Requisition No. EZ899- 220723/A

The following changes in the tender documents are effective immediately. This addendum will form part of the Contract documents.

Project title/Titre du projet
 3000 AIRPORT ROAD
 PENTICTON, BC
 PENTICTON REGIONAL AIRPORT
 PENTICTON ATB
 ROOF SEISMIC UPGRADE
 ROOFING & BUILDING
 ENVELOPE PROJECT

Drawing title/Titre du dessin
 BUILDING ELEVATIONS

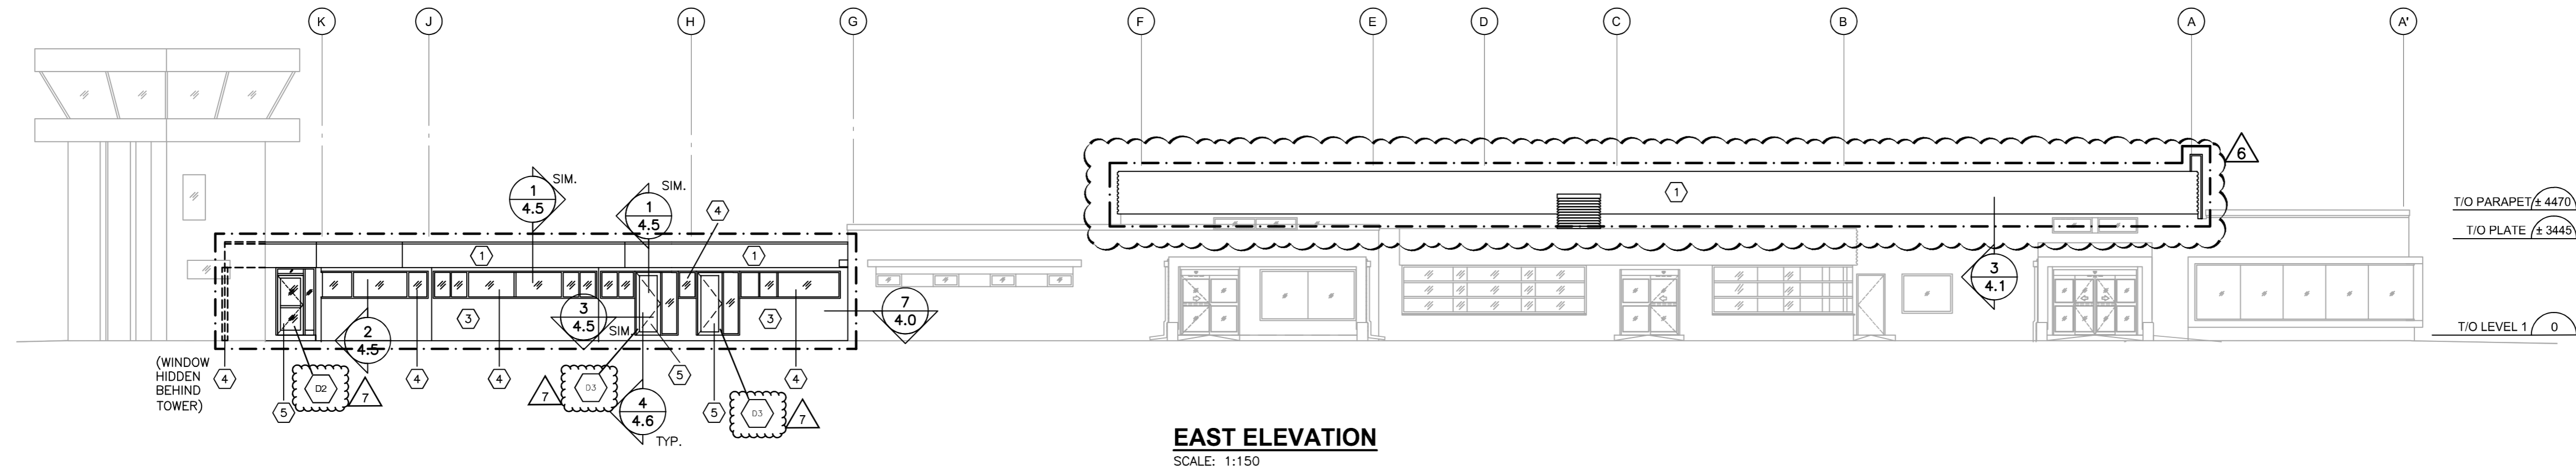
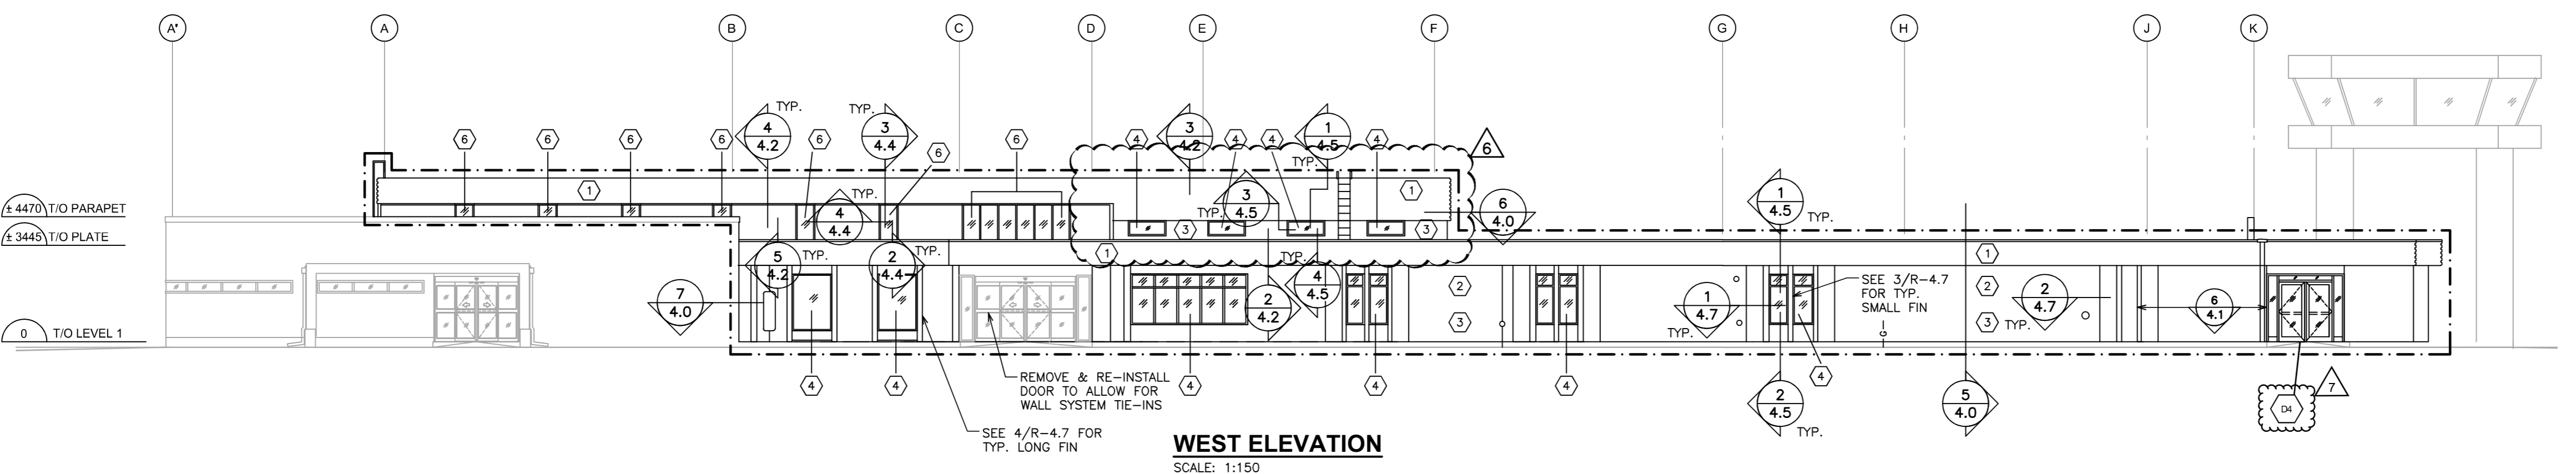
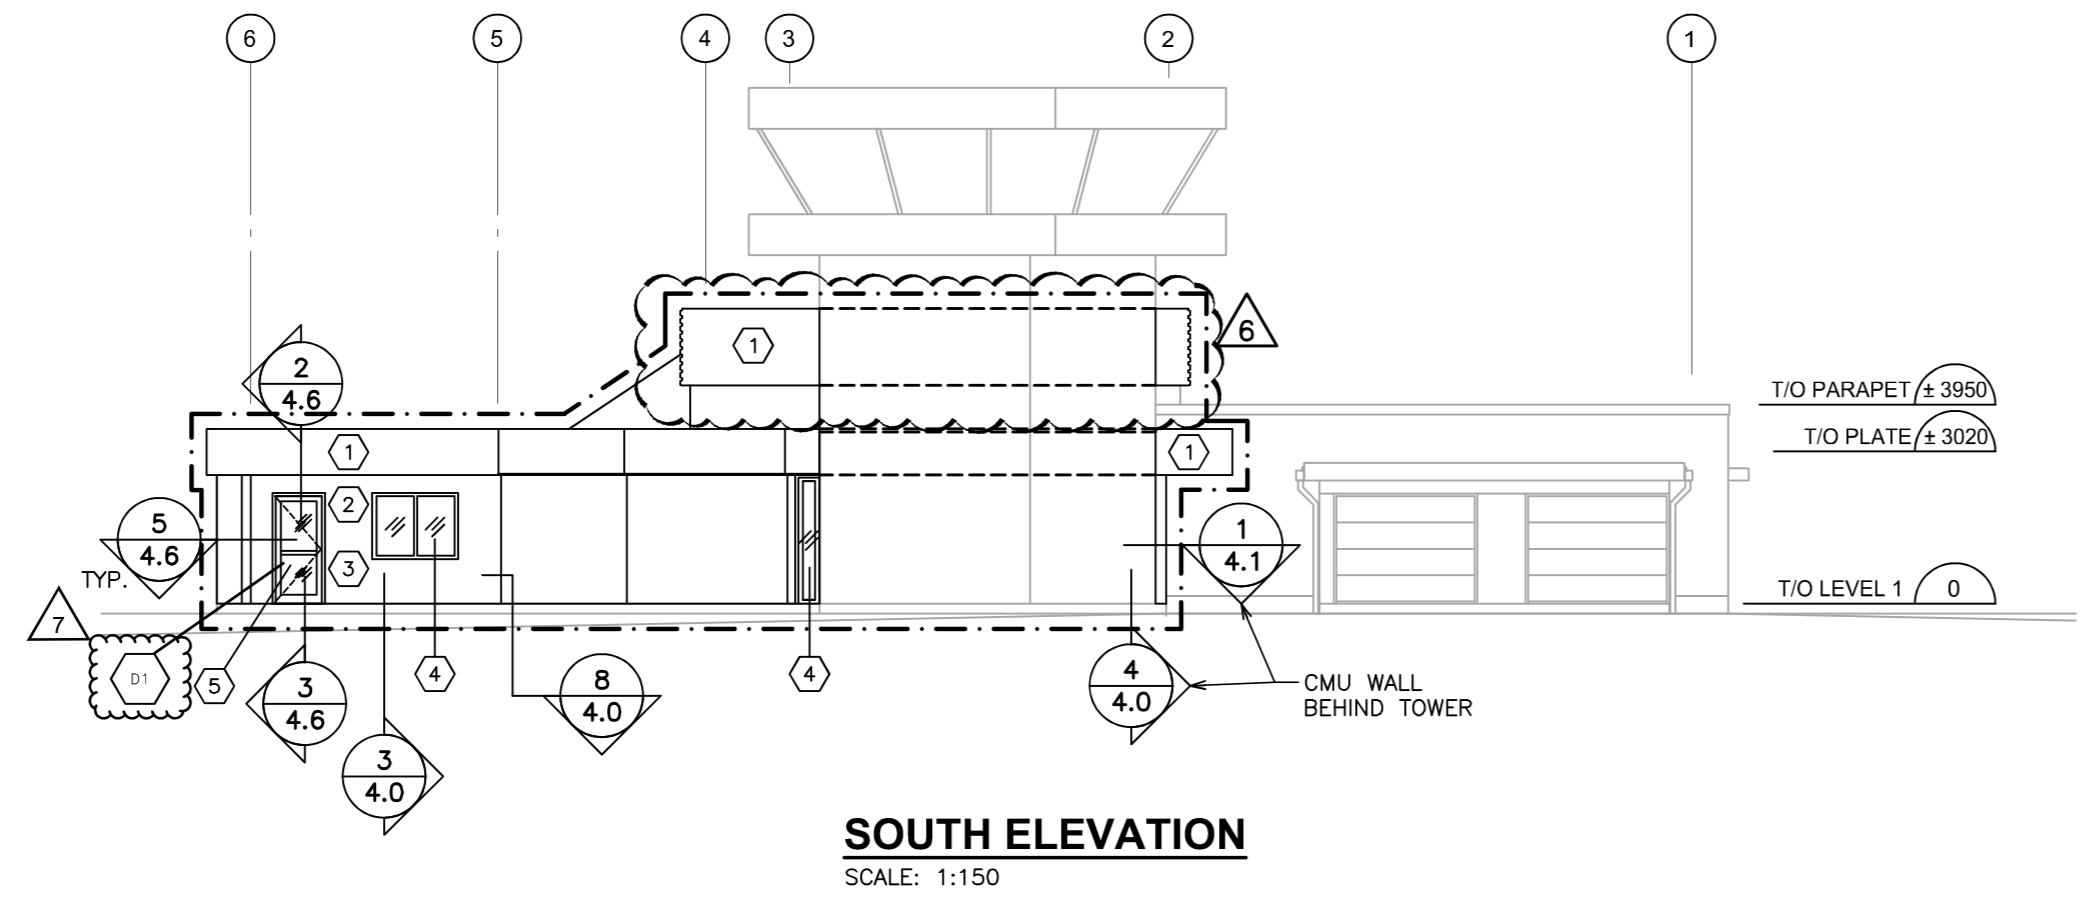
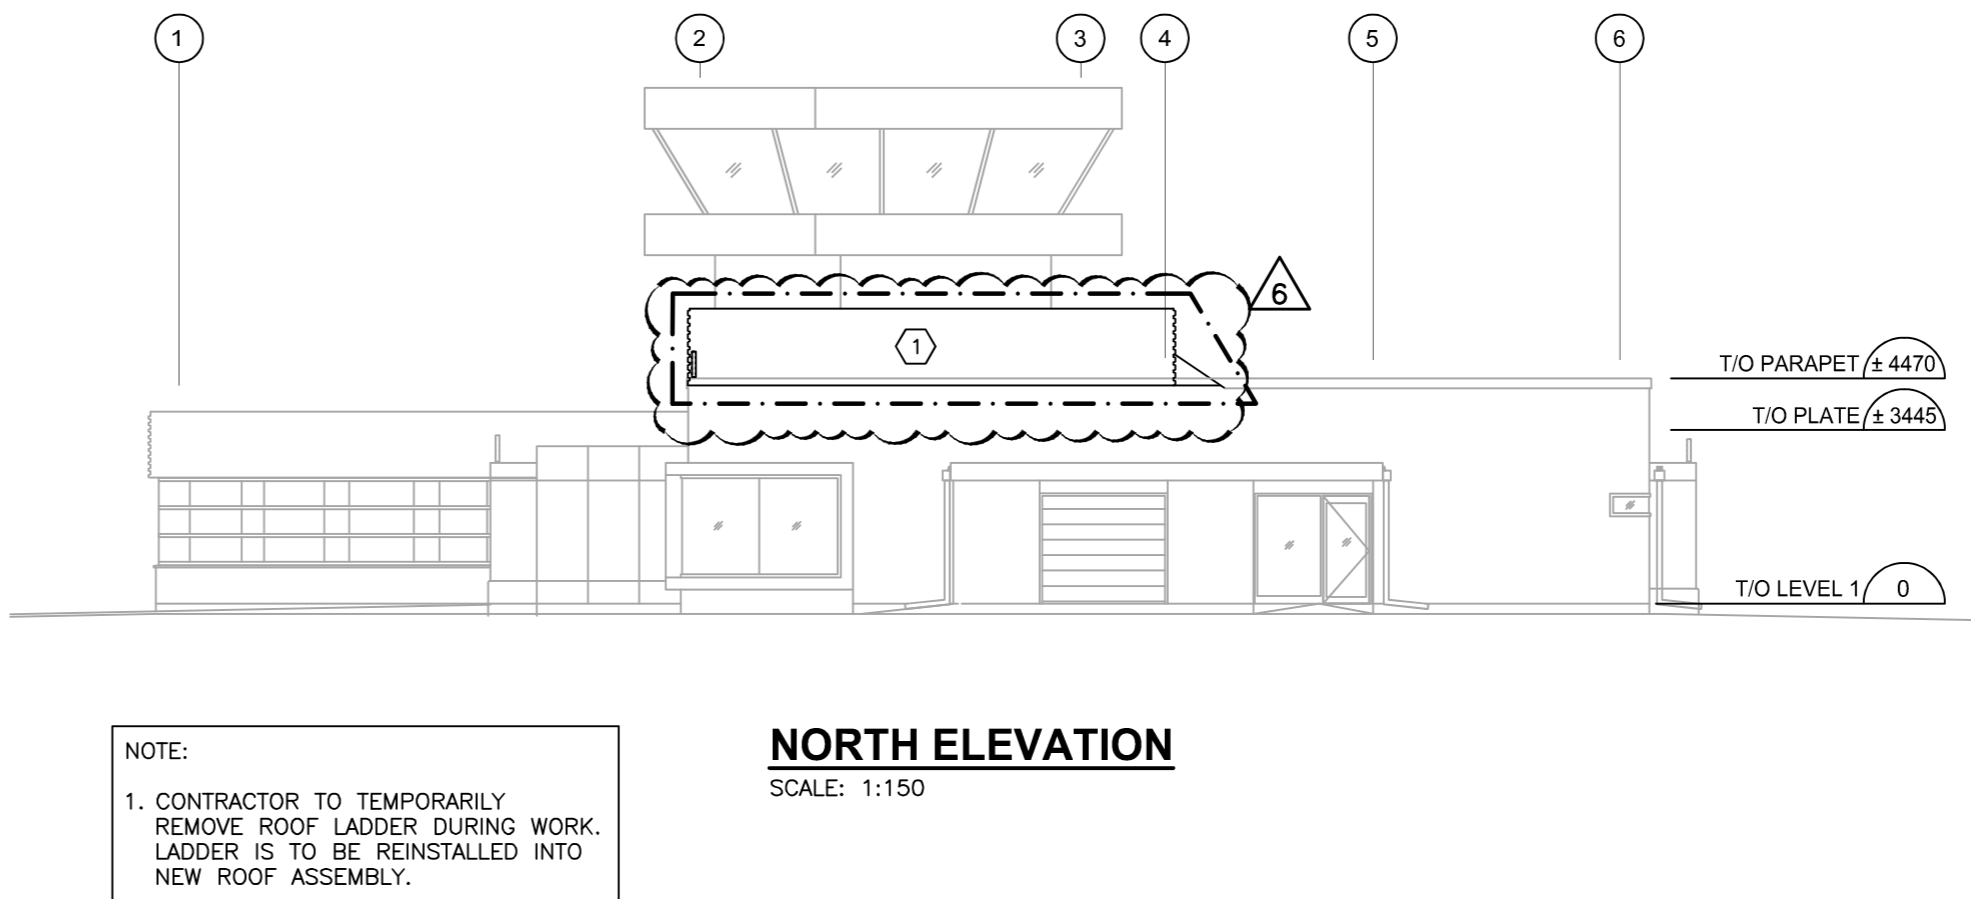
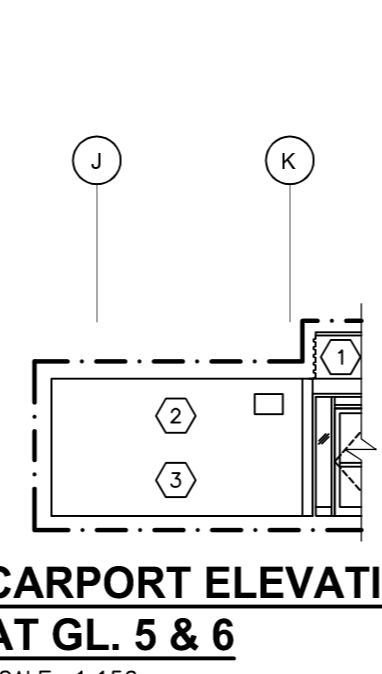
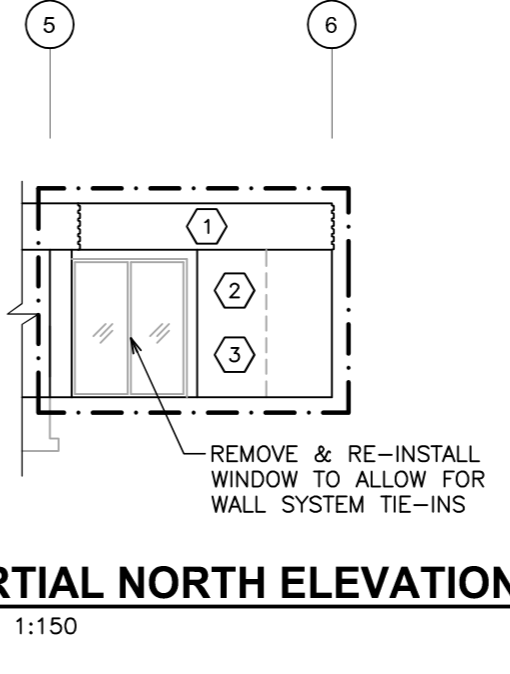
- Drawing R-3.0, revised door schedule callouts. See attached sheet.
- Drawing R-5.0, revised glazing schedule. See attached sheet.

GLAZING SCHEDULE

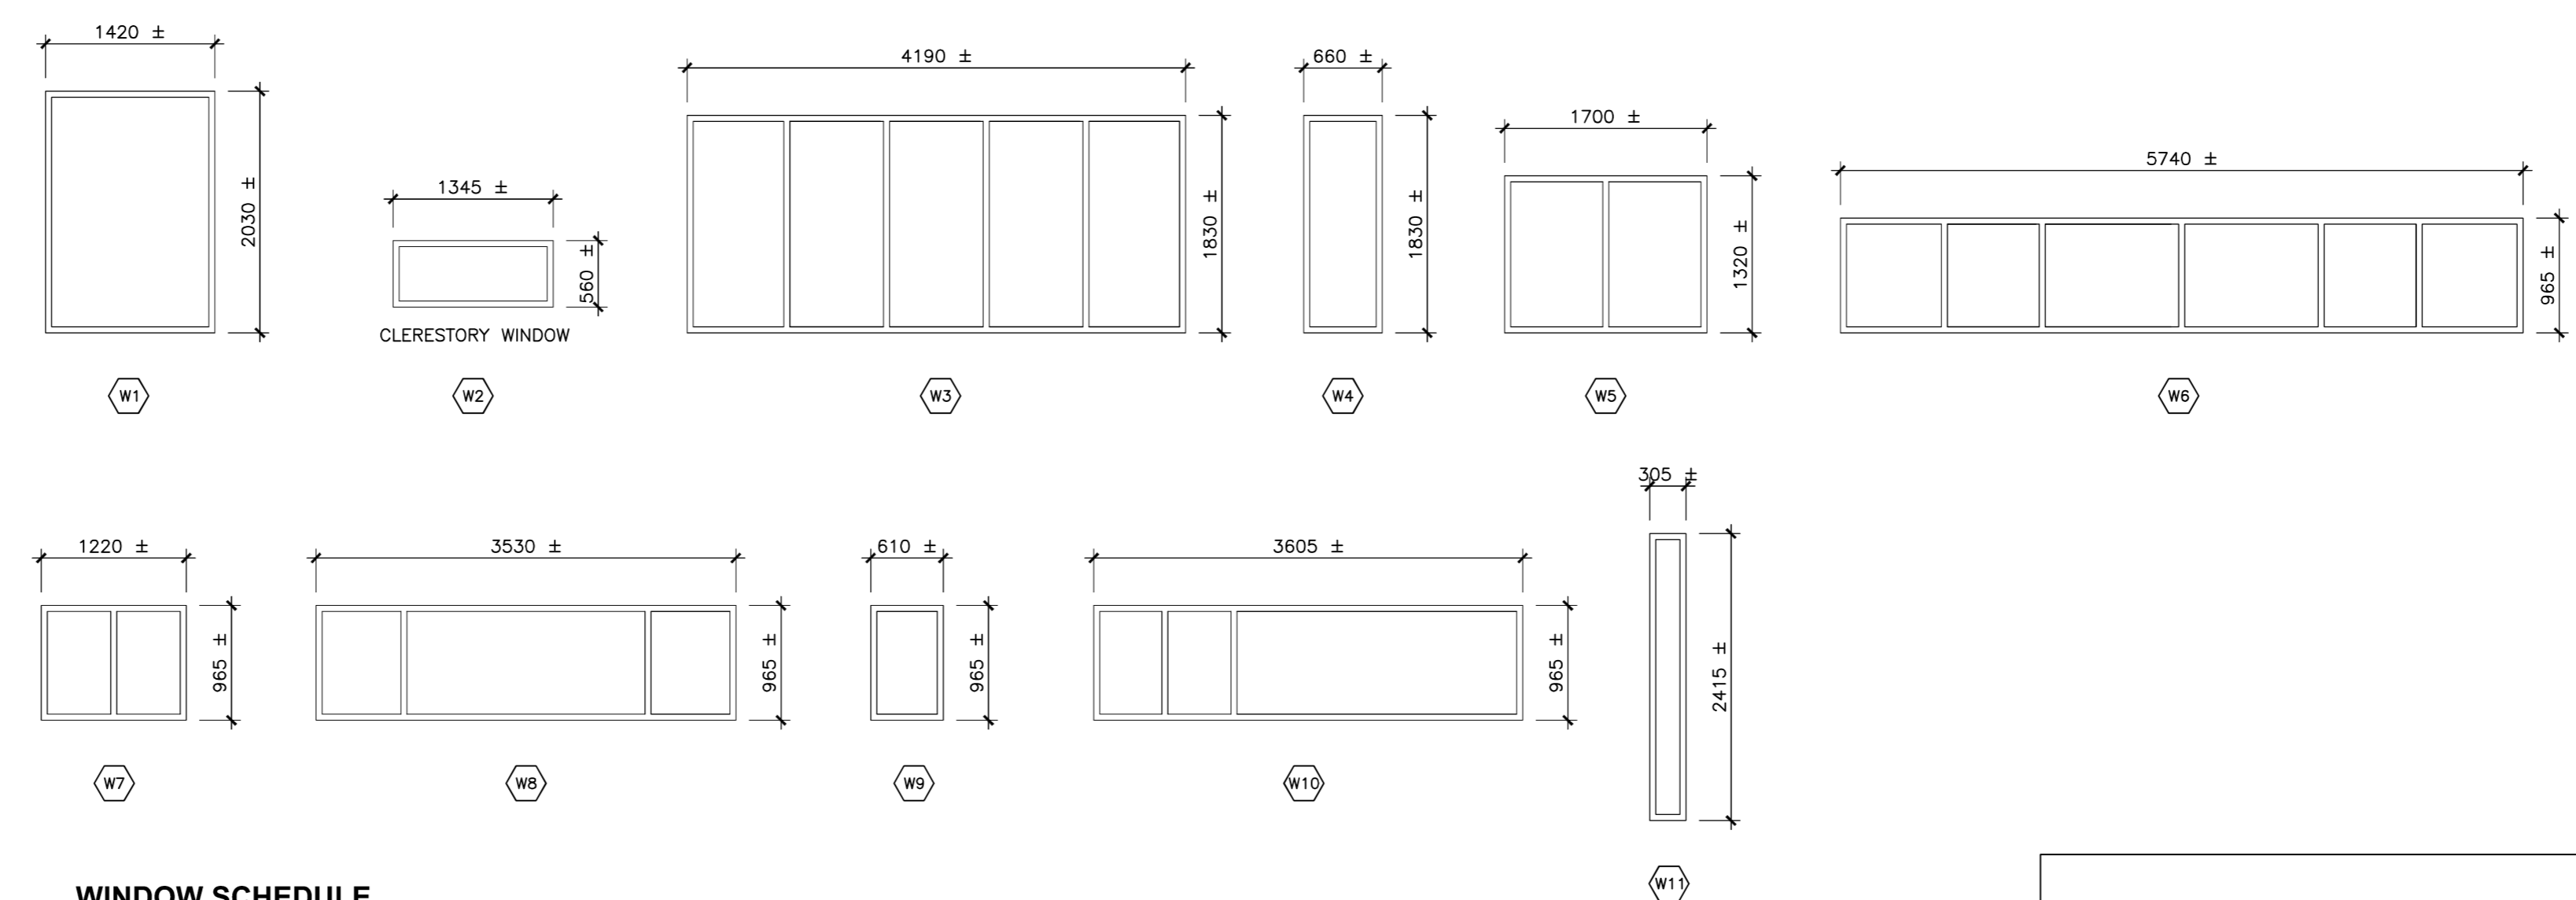
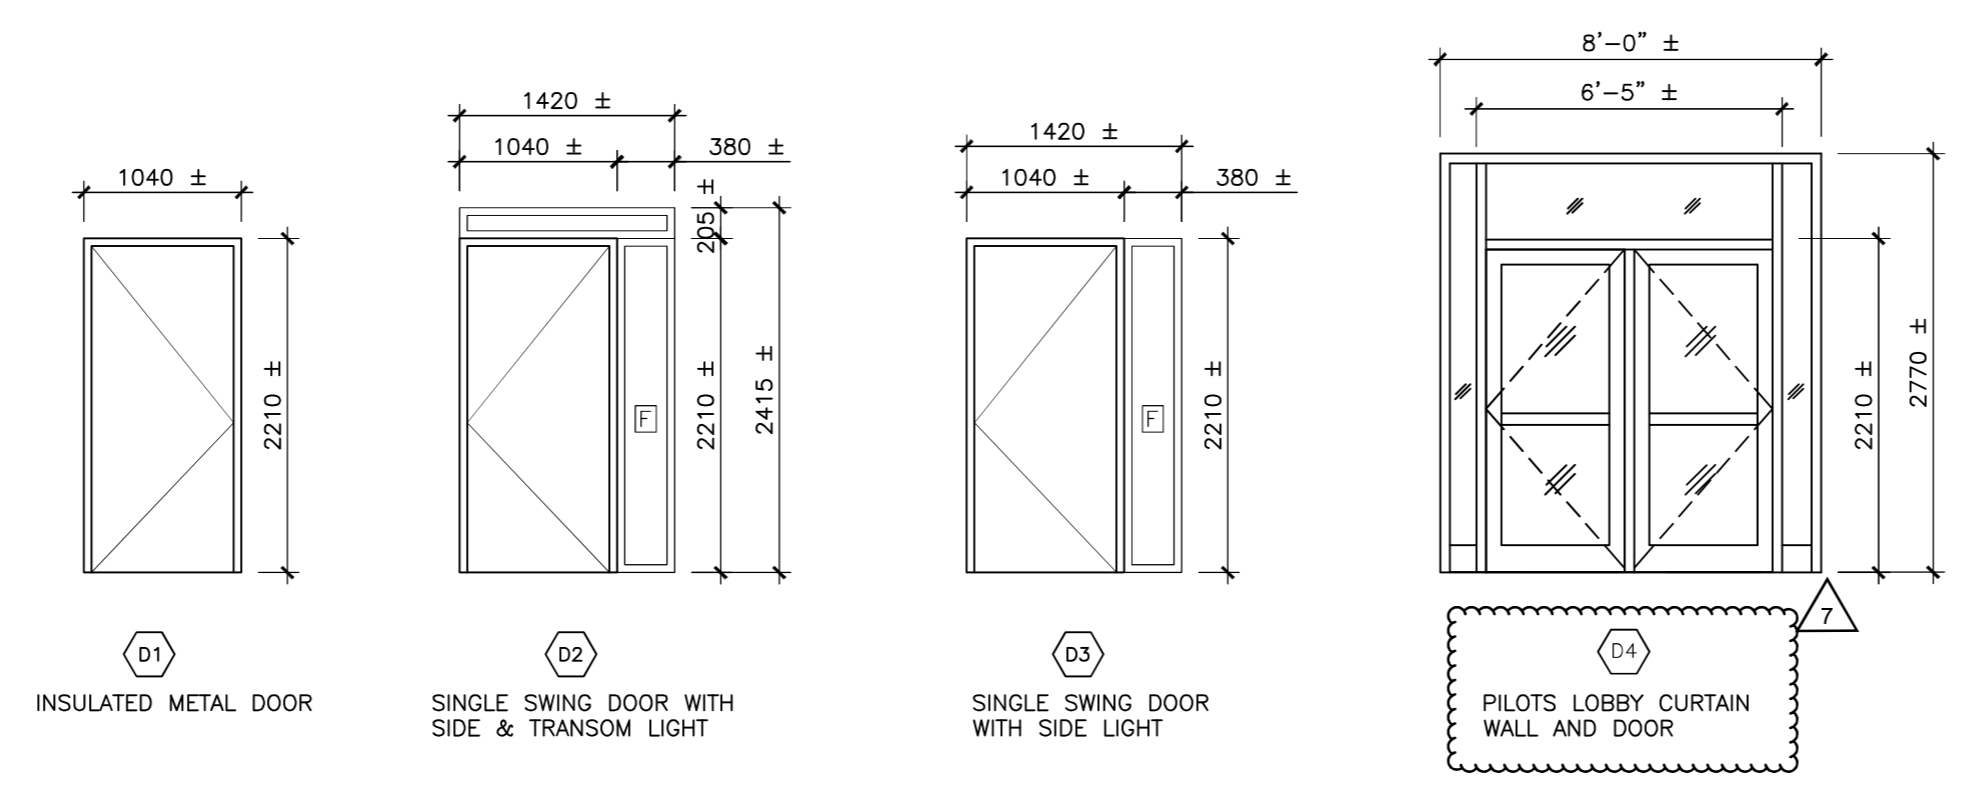
- Q.1 To re-phrase Q.5 in Addendum 003 “Necessary to provide direction for our Doors & Hardware subcontractors, please provide a door schedule with quantities and locations.”, the door schedule provided (R-5.0) shows the Door type, but elsewhere in the drawings these door types are not labelled... without locations, we are unable to decipher the quantity of each door type required. Also, please provide information on the material for door types, D2 & D3.

- A.1 *Refer to section 1 of Addendum. Type D2 and D3 are to be triple glazed curtain wall in accordance with the specifications.*
- Q.2 To re-phrase Q.7 in Addendum 003 “To clarify, as per Addendum 002 A.10, please confirm all roof plywood sheathing is to be removed and replaced – reflecting in an approximate area of 1022 m² based on what is identified on the roof plan, R-2.1.”, please confirm all existing roof plywood sheathing is to be removed and replaced within the constraints of the “extent of work” shown in the legend on R-2.1, and are not otherwise restricted to more specific areas within the roof plan.
